Submission Details for Mal Brown of Northrop (comments)

RE: Submission to Western Sydney Aerotropolis Draft LUIIP, Stage 1: Initial Precincts

Summary of objection: Adoption of PMF extents to define South Creek Precinct

Figure 1: 50 Kelvin Park Road land with proposed indicative zoning shown

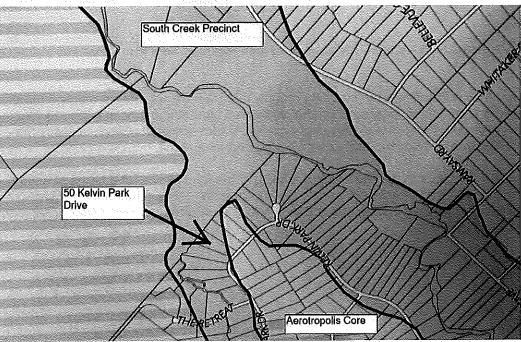
I represent a client who owns land at 50 Kelvin Park Drive, Bringelly. The site has a total area of 20,000m². According to the LUIIP, this land has been provided with indicative zoning comprising two zoning types (Figure 1), as follows:

- Non-urban (South Creek Precinct) approx 98%
- Aerotropolis Core approx 2% (450m²)

It is apparent that the Non-urban zoning has been applied to achieve a green corridor along South Creek and its tributaries. While my client is supportive of the notion of a green corridor, they are opposed to it being defined by the Probable Maximum Flood (PMF) level. This submission explains why.

Adoption of the PMF to define a Non-urban zone is unprecedented and unsupported. The 1% AEP level should be adopted as the appropriate flood planning level for this zone.

Figure 2: Extract of Liverpool City Council's Flood Planning Area Map

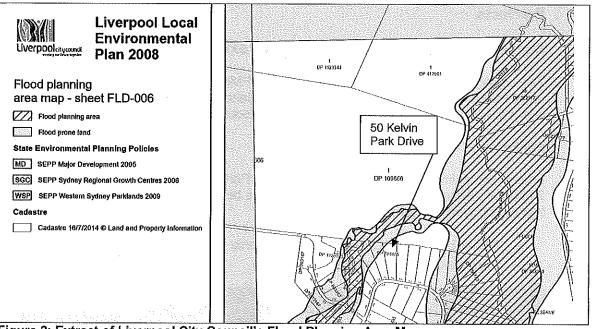
Council's LEP flood planning area map which covers 50 Kelvin Park Drive is shown in Figure 2. It shows that my client's site is **not within the Flood Planning Area**, and only a small portion of the land in the northwest (<5%) is Flood Prone. It also provides an indication of the likely extent of land available for a green corridor.

The non-hatched green area (equating roughly to a PMF extent) provides only a marginally increased area of land for green corridor, while also sterilising many lots from development. The benefit derived by way of a slightly larger green corridor does not appear to justify the amount of otherwise developable land that would be sterilized as a result.

Figure 3: Flood risk at Bringelly

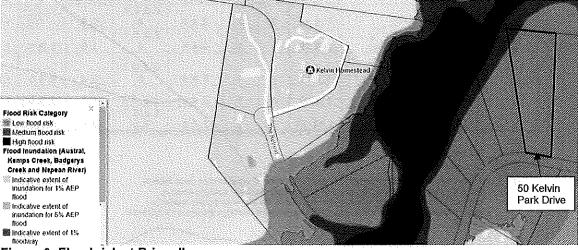
For point ii. it refers to the *Liverpool DCP 2008* for details. Liverpool City Council has characterised the flood risk of the site (Figure 4) as follows:

- 98% Low Flood Risk
- 2% Medium Flood Risk

Figure 4: 40m VRZ and its minor effect on the property at 50 Kelvin Park Drive

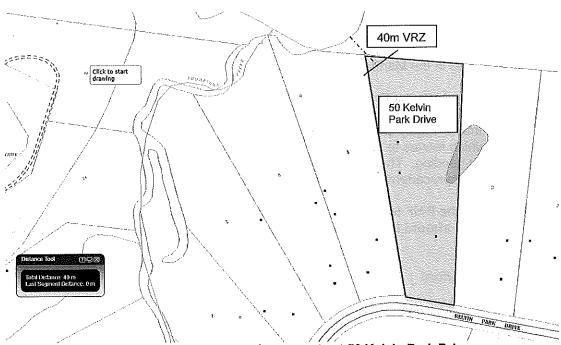
The maximum VRZ width in the Guidelines is for 4th order waterways (rivers) and is 40m wide. Thompsons Creek (to the immediate north of the site) is a 2nd order waterway, requiring only a 20m wide VRZ. To be conservative, we have applied a maximum 40m wide VRZ to Thompsons Creek (Figure 4). The resulting VRZ affects a very small portion of the north-western corner of the

A fully functioning green corridor (Non-urban zone) can be created adjoining the site by applying the riparian Guidelines.

The creation of a green corridor defined by the PMF (as is proposed in the Draft LUIIP) is unprecedented and unsupported. The riparian lands Guidelines should be used in conjunction with 1% AEP flood extents to define green corridors adjoining waterways in the Aerotropolis lands.
